EPA Region 8
Underground Injection Control (UIC) Program
Response to Public Comments

Class III Area Permit No. SD31231-00000, Aquifer Exemption Decision
And
Class V Area Permit No. SD52173-00000

Powertech (USA) Inc.
P.O. Box 448
Edgemont, South Dakota 57735

Final Permit issuance: November 24, 2020

Figure A. Gott et al., 1974, Plate 2 showing the extent of the Dewey Fault and Structural Zone with the Dewey-Burdock Project Area superimposed.

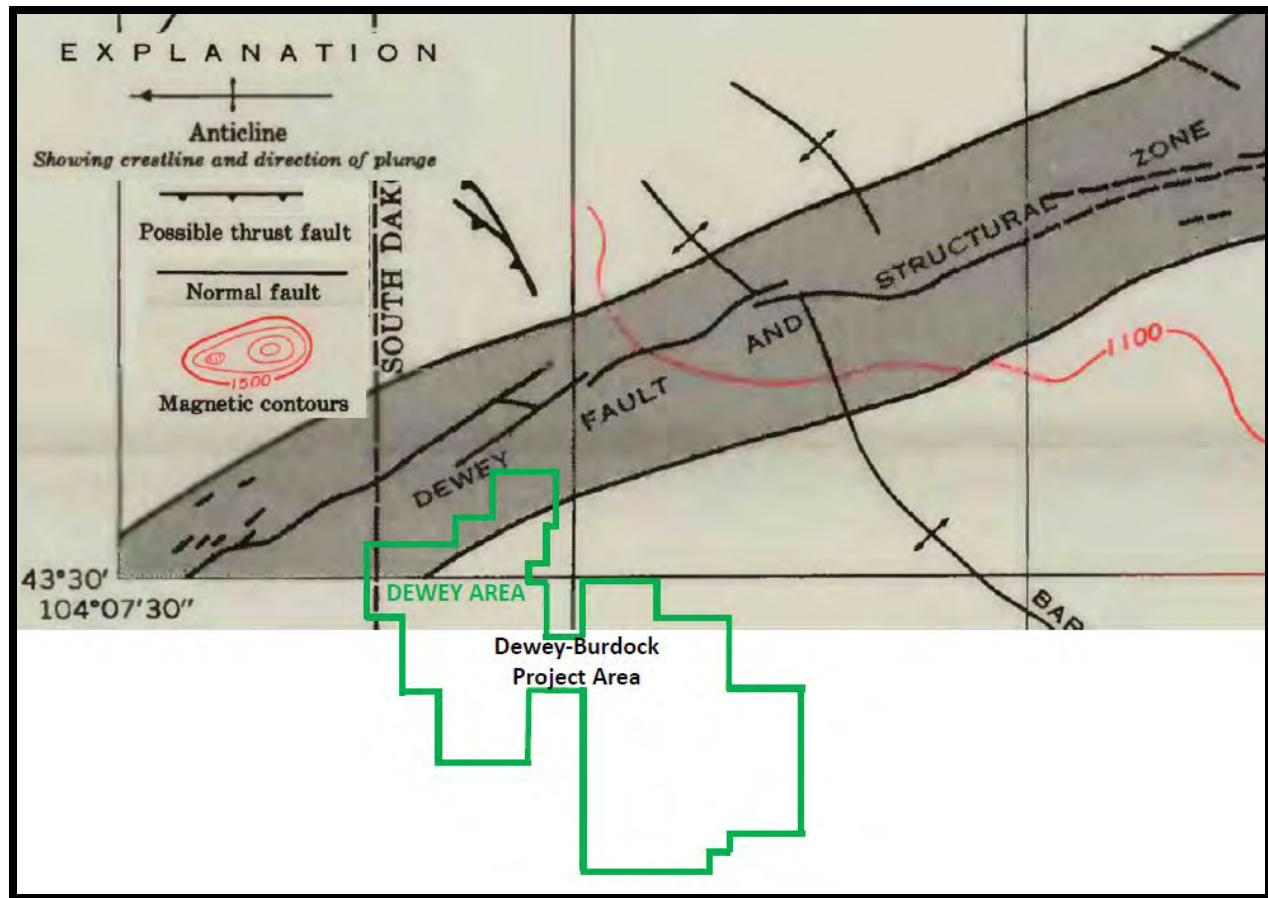
There is no evidence of the Dewey fault inside the project area. (Brobst, 1961, *Geology of the Dewey Quadrangle Wyoming-South Dakota*, USGS Bulletin 1063-B.) Brobst, 1961, describes the Dewey Fault in the Dewey quadrangle geologic report as the fault passing through the town of Dewey and refers to the fault located to the southeast without a name. Braddock, 1963, does not refer to more than one fault plane related to the Dewey Fault in the Geology of the Jewel Cave SW quadrangle report (Braddock, W.A., 1963, *Geology of the Jewel Cave SW quadrangle Custer County, South Dakota*, USGS Bull 1063-G). Gott, et al., 1974, includes both faults described by Brobst, 1961, in the Dewey Fault and Structural Zone. The boundaries of this structural zone are shown in Plates 2 and 4 of the Gott et al., 1974 report. The extent of the Dewey Fault and Structural Zone as defined by Gott in Plate 2 near the Dewey-Burdock Project Site is shown in Figure A. The Dewey-Burdock Project Site Boundary is superimposed on Plate 2. Although Gott shows the Dewey Fault and Structural Zone as extending into the northwestern edge of the Dewey-Burdock Project Site, there is no evidence of any fault inside the Project Area.

Figure B. Excerpt from Gott et al., 2001, Plate 4 showing features inside the Dewey-Burdock Project Boundary.

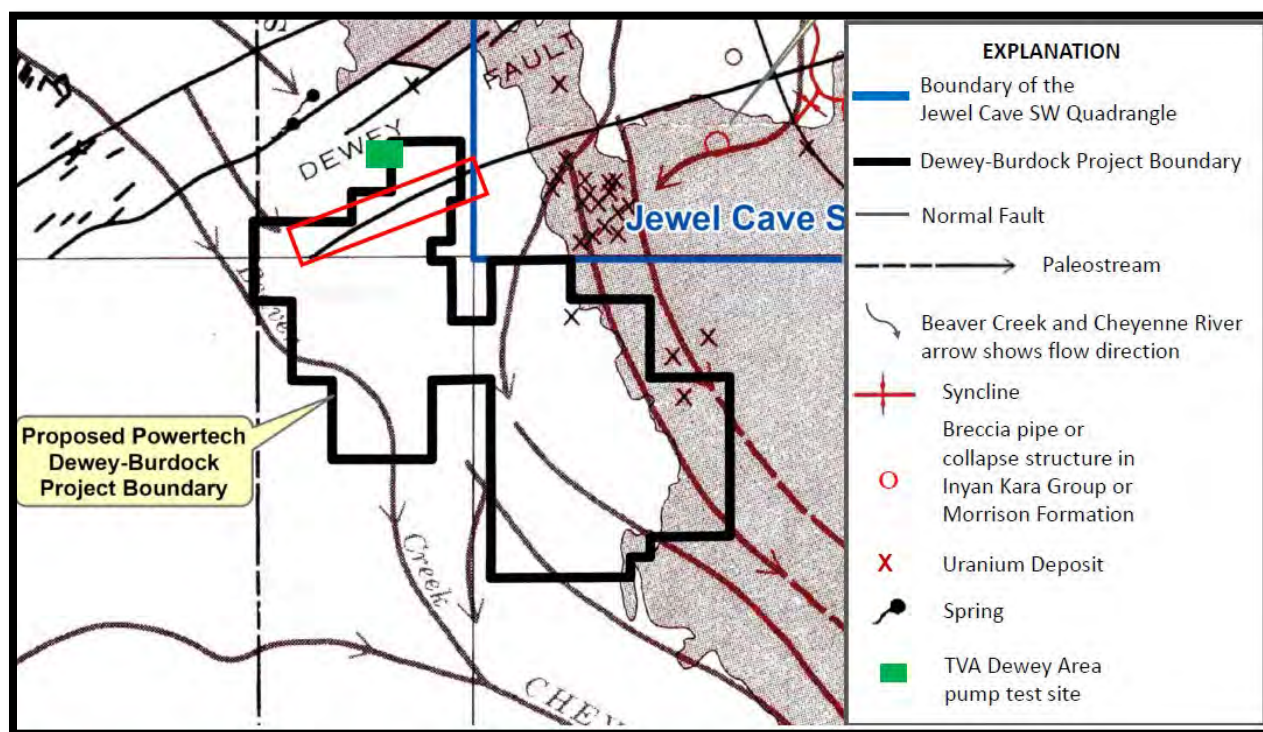
A commenter referred to Plate 4 from Gott et al., 1974, as the Gott fault map. Powertech used Plate 4 as a base map for Plate 6.24 of the Class III Permit Application and superimposed the Dewey-Burdock Project Boundary to show where the collapse features and breccia pipes identified in Gott et al., 1974, are located relative to the Project Site. Plate 6.24 shows that none of these features are located inside the Project Area. Figure B is an excerpt from Plate 6.24. The features shown inside the project boundary are Beaver Creek and paleostreams. The linear feature in the red box inside the Dewey-Burdock Project Area is the southeast boundary of the Dewey-Fault and Structural Zone shown in Plate 2.

EPA disagrees with the commenter's statement that the features in Plate 4 demonstrate that EPA failed to conduct the necessary physical surveys to confirm or deny the presence of these geological features. Based on the discussion above regarding the features identified in Plate 4 within the Project Area, there is no need for EPA to perform a physical survey because no disruption of confining zones in the currently proposed wellfield areas is indicated by the information in Plate 4.

Figure C. Dewey wellfield locations relative to the possible normal fault location in the Dewey-Burdock Project Boundary.

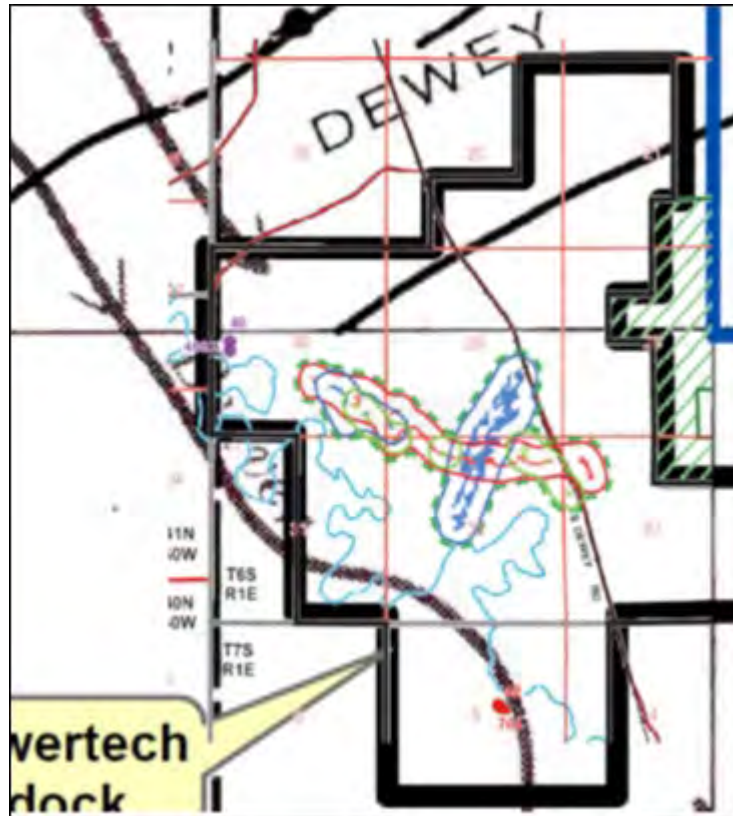
Figure C shows that the southeastern edge of the Dewey Fault and Structural Zone does not intersect the proposed wellfields in the Dewey Area, so it is not of concern for the currently proposed for ISR operations. The fact that the Dewey Fault and Structural Zone is located upgradient of the Dewey wellfields and the inward hydraulic gradient required for each wellfield will prevent ISR injection interval fluids from migrating to the location of this zone. If Powertech proposes future wellfields in this area, correlation of drillhole data in the area would identify any offset of geologic strata caused by the presence of a fault.

Figure D. Potentiometric surface contour maps of the Fall River and Chilson aquifer from Figures 5.2 and 5.3 of the Class III Permit Application.

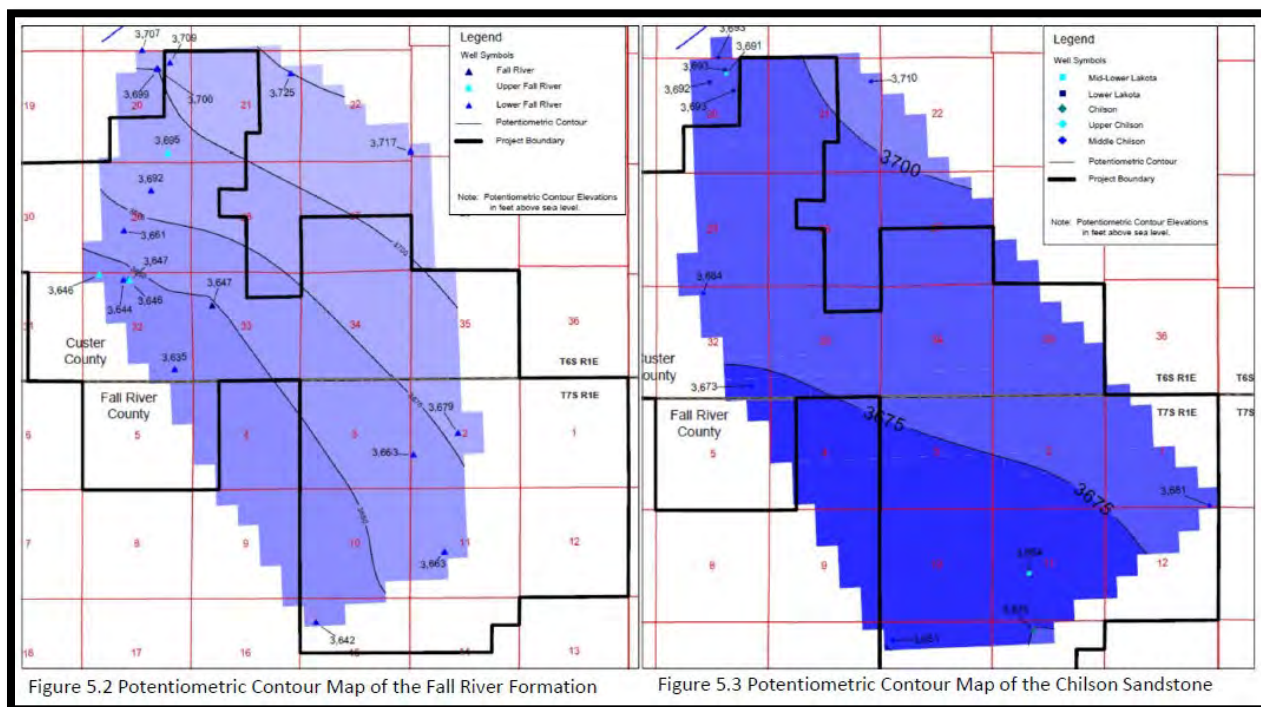
EPA disagrees with the interpretation that the potentiometric surface of the Fall River aquifer and the Chilson aquifer being at similar elevations in the vicinity of wellfields 6, 7 and 8 indicates leakage through the Fuson confining zone in this area. Figure D shows the potentiometric surface contours of the Fall River and Chilson aquifer based on water level measurements in wells completed in each aquifer.

These maps show that the potentiometric surface of the Fall River aquifer is at a higher elevation than that of the Chilson in the northeastern portion of the project area. The Chilson aquifer potentiometric surface is at a higher elevation than that of the Fall River aquifer in the southwestern portion of the project area. At some point these potentiometric surface elevations are at the same elevation, as demonstrated by the cross-sections shown in Plates 6.13 and 6.14 of the Class III Permit Application. EPA concludes that this is the reason for the similarity in elevation of the Fall River and Chilson potentiometric surfaces in the vicinity of Burdock Wellfields 6, 7 and 8.

Figure E. Areas of the Inyan Kara Group aquifers approved by this Record of Decision.

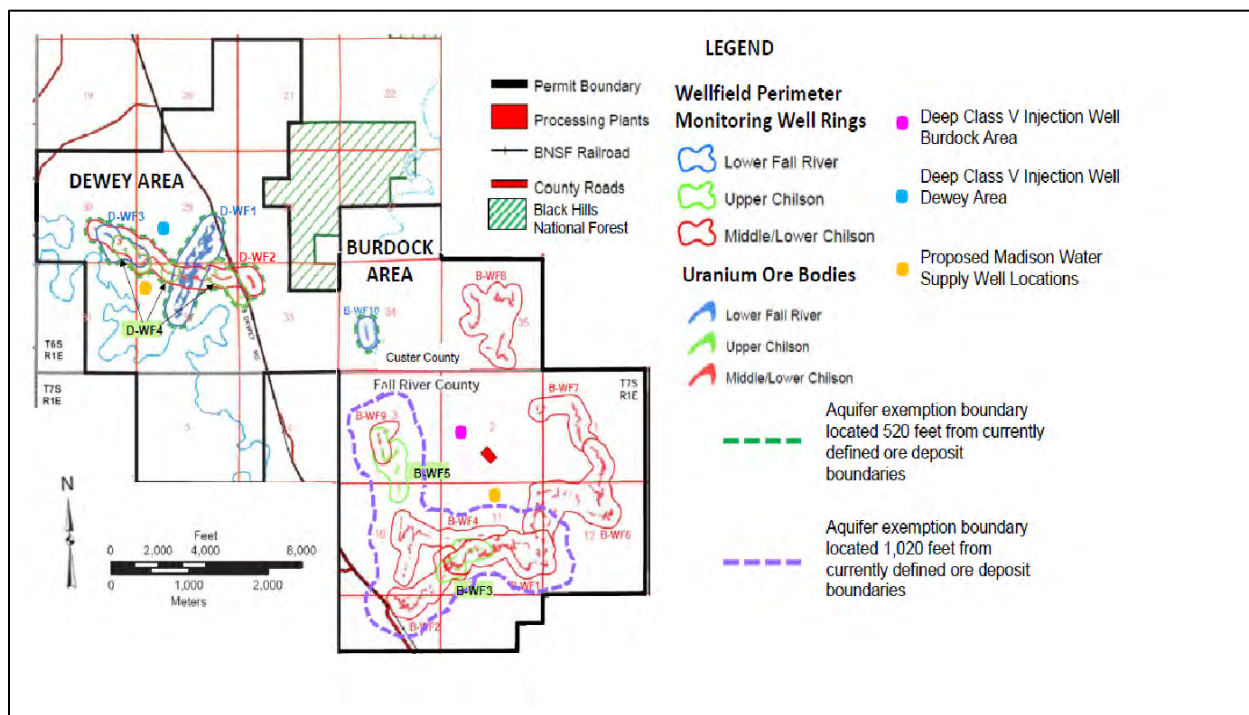
Powertech requested an expanded AE area to accommodate additional ore resources identified after the Class III Permit Application was submitted. EPA reviewed the Preliminary Economic Assessment reports developed by consultants documenting independent audits of mineral resource estimates at the Dewey-Burdock Project Site and determined that the commercially producible ore resource boundary had expanded in Burdock Wellfields 1 through 5, 9 and 10 since Powertech submitted the Class III Permit Application, justifying expanding the AE boundary for these wellfields. However, the commercially producible ore resource boundaries had not expanded for the other wellfields, so EPA did not expand the AE boundaries for these other wellfields. Because Powertech needs to do additional work to demonstrate that the potentiometric surfaces in Burdock Wellfields 6, 7 and 8 are able to sustain adequate monitoring of ISR operations in the overlying Upper Chilson aquifer, EPA is postponing approval the aquifer exemption in the area of Burdock Wellfields 6, 7 and 8 until Powertech performs further aquifer testing in that area.

Figure F. Minnelusa aquifer groundwater flow direction map from Figure 17, Driscoll et al., 2002.

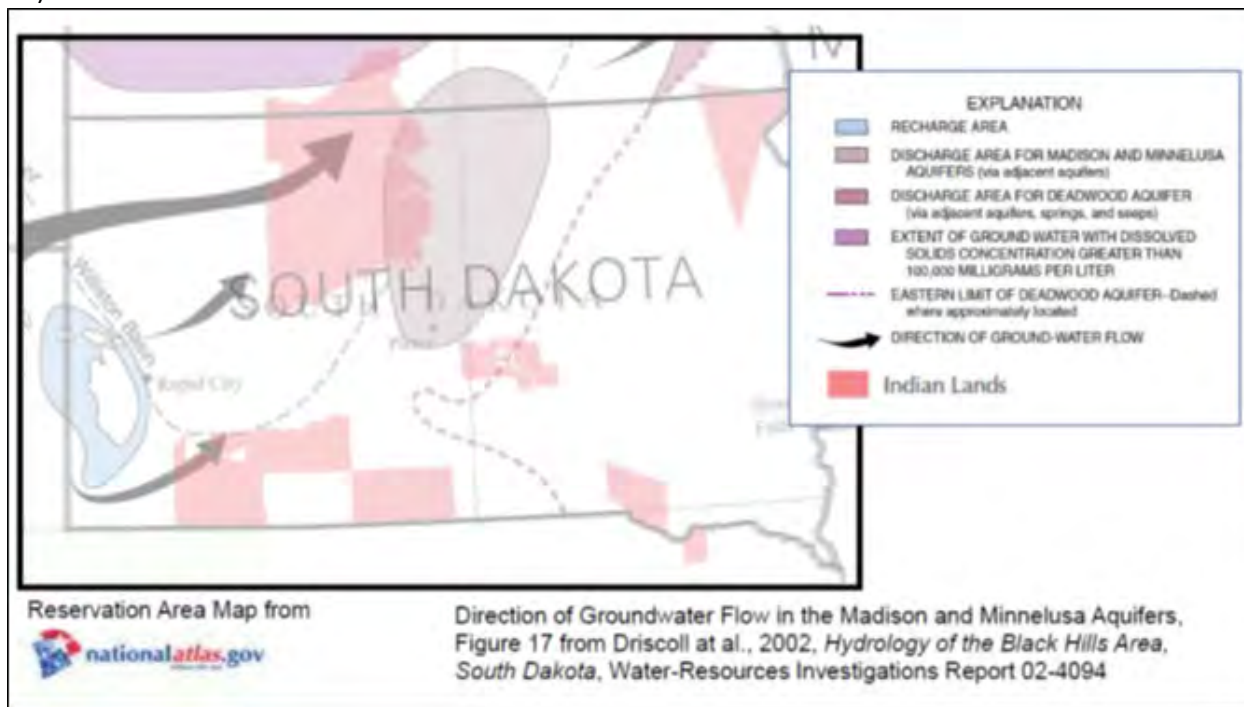
EPA investigated groundwater flow directions in the Minnelusa aquifer at the Dewey-Burdock Project Site and at the springs, such as Cascade Springs, south of the Black Hills. Figure F is a groundwater flow direction map from Figure 17 in Driscoll et al., 2002. This map shows the direction of groundwater flow in the Minnelusa aquifer from its recharge area in the Black Hills to a discharge area located at the eastern edge of the Cheyenne River Reservation. As shown in the map in Figure F, the authors hypothesize that the Minnelusa aquifer groundwater flows from the Dewey-Burdock site and flows around the southern end of the Black Hills toward the Williston Basin. (Driscoll, D.G., et al., 2002, *Hydrology of the Black Hills Area, South Dakota*, USGS Water-Resources Investigations Report 02-4094 at 22)

Figure G. Minnelusa aquifer potentiometric surface elevation contours in the area where springs occur south of the Black Hills (from Sheet 2, Strobel et al., 2000)

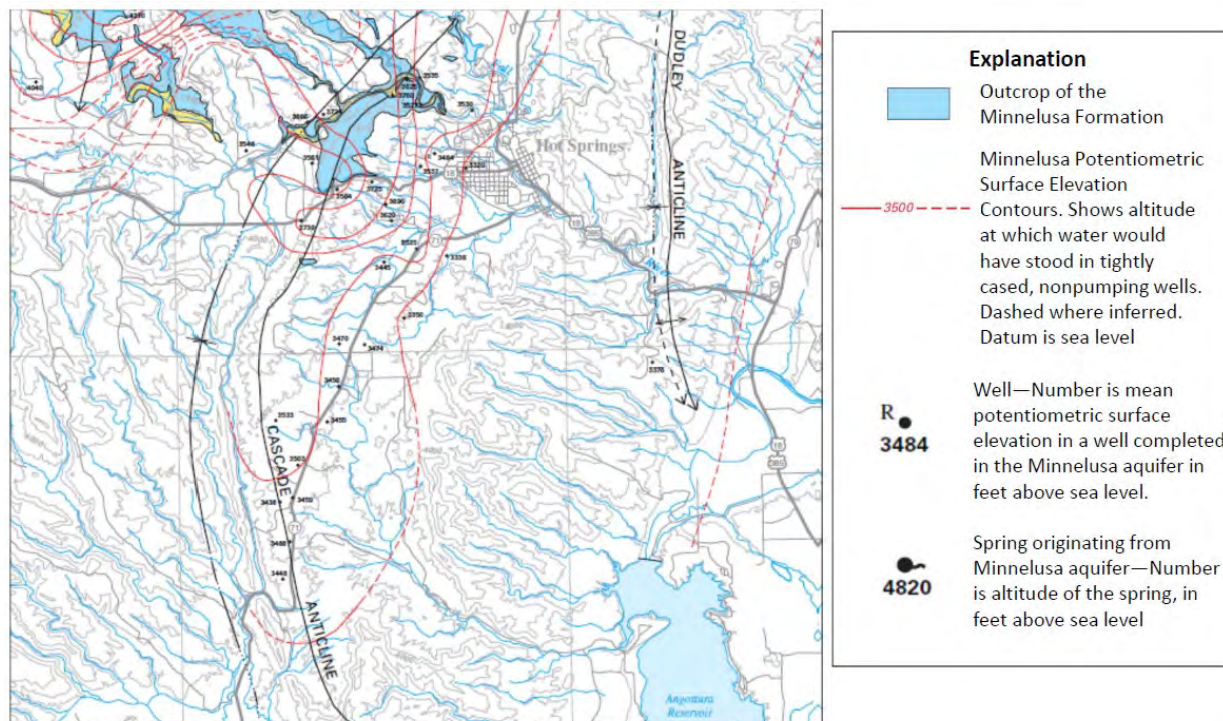
Figure G is the area where springs, including Cascade Springs, are located south of the Black Hills, excerpted from Sheet 2 of Strobel et al., 2000. The red lines show the potentiometric surface elevations based on wells completed in the Minnelusa and springs flowing from the Minnelusa. The potentiometric surface contours are deflected southward along the Cascade anticline where the Minnelusa and other geologic strata are raised in elevation. (Strobel et al., 2000)

Figure H. Elevation of the Minnelusa Formation top surface (Source: Sheet 2 of Carter and Redden, 1999)

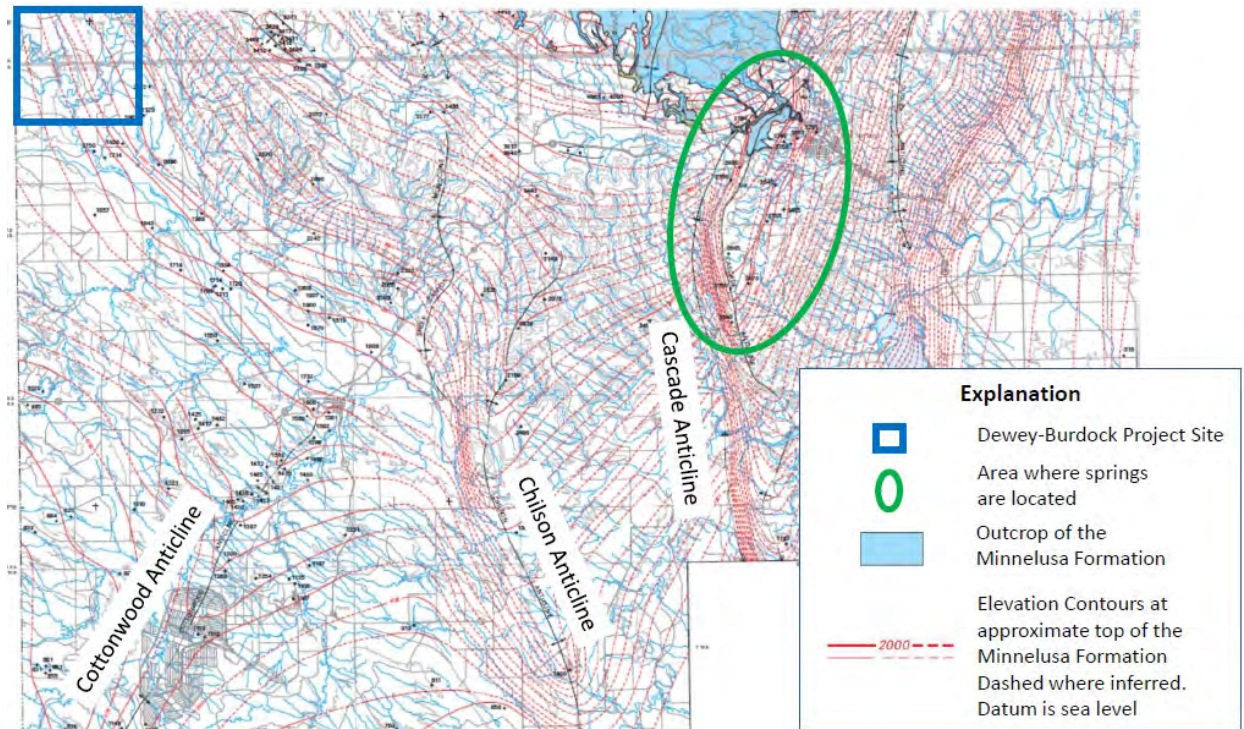
Figure H shows the area south of the Black Hills, excerpted from Sheet 2 of Carter and Redden, 1999. (Carter, J.M. and Redden, J.A., 1999, *Altitude of the Top of the Minnelusa Formation in the Black Hills Area, South Dakota*, USGS Hydrologic Investigations Atlas HA-744-C, Sheet 2) In this figure the red lines are elevation contours along the top of the Minnelusa Formation. The springs shown in Figure G are located inside the green oval. Based on the elevation of the top of the Minnelusa Formation shown in the area where springs occur south of the Black Hills, the top of the Minnelusa Formation is at a higher elevation at this location than at the Dewey-Burdock Project Site. Figure H shows how the Cottonwood, Chilson and Cascade anticlines affect the Minnelusa Formation elevation. The Class V injectate from the Dewey-Burdock site would have to flow uphill to reach the location of these springs. Based on the potentiometric surface contours in Figure G, the flow path of Class V injectate would be deflected to the south by the Chilson and Cascade anticlines and would have to flow uphill to reach these springs where Minnelusa and Madison groundwater flows to the surface.

Figure I. Locations of springs emanating from or passing through the Minnelusa aquifer, from Figure 29 of Naus et al., 2001.

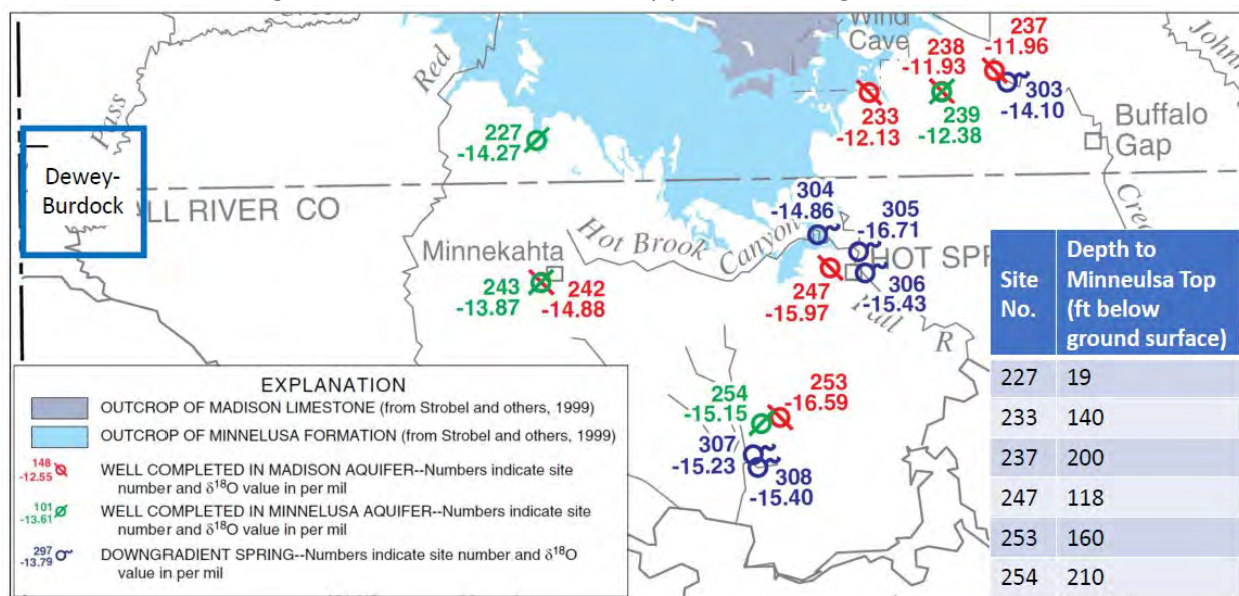
EPA reviewed water well logs in the area near the springs flowing from the Minnelusa and Madison aquifers. Figure I shows locations of Minnelusa (green) and Madison (red) wells and springs. The blue table in Figure I shows the depth to the top of the Minnelusa Formation in the logs for wells shown in Figure H. The springs occur where the top of the Minnelusa aquifer occurs closer to the ground surface. For example, at the location of the springs shown in Figure H the top of the Minnelusa is approximately 200 feet or less below ground surface, based on nearby private well logs.

Based on this analysis, EPA concludes that the Class V injectate will not contaminate the Madison aquifer and will not reach the area where the artesian springs are located.

Figure J. Locations of earthquakes occurring between 1872 – 2013 in southwest South Dakota from the South Dakota Geological Survey website.

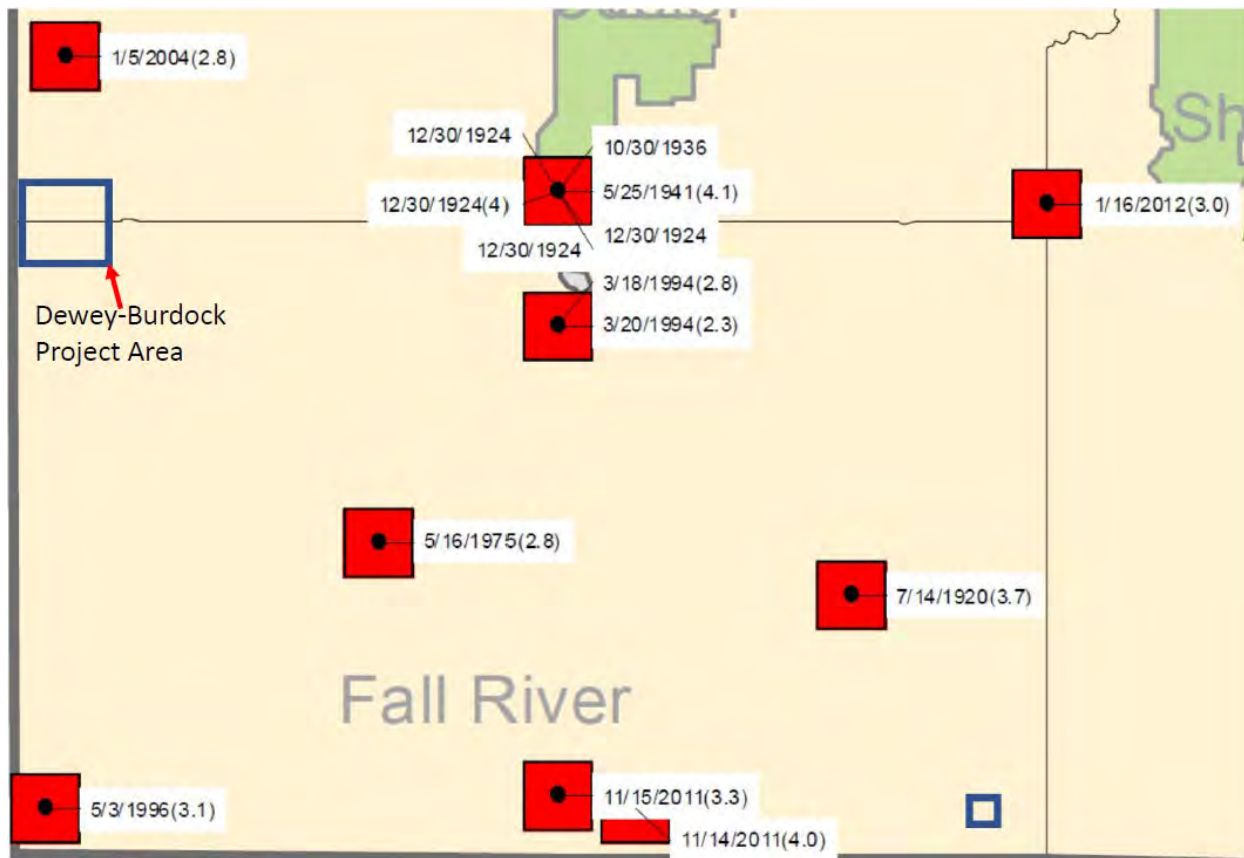
Figure J shows locations of earthquakes that have occurred between 1872 - 2013 in southwestern South Dakota including the earthquakes mentioned by the commenter. This map is available on the [South Dakota Geological Survey website](#).
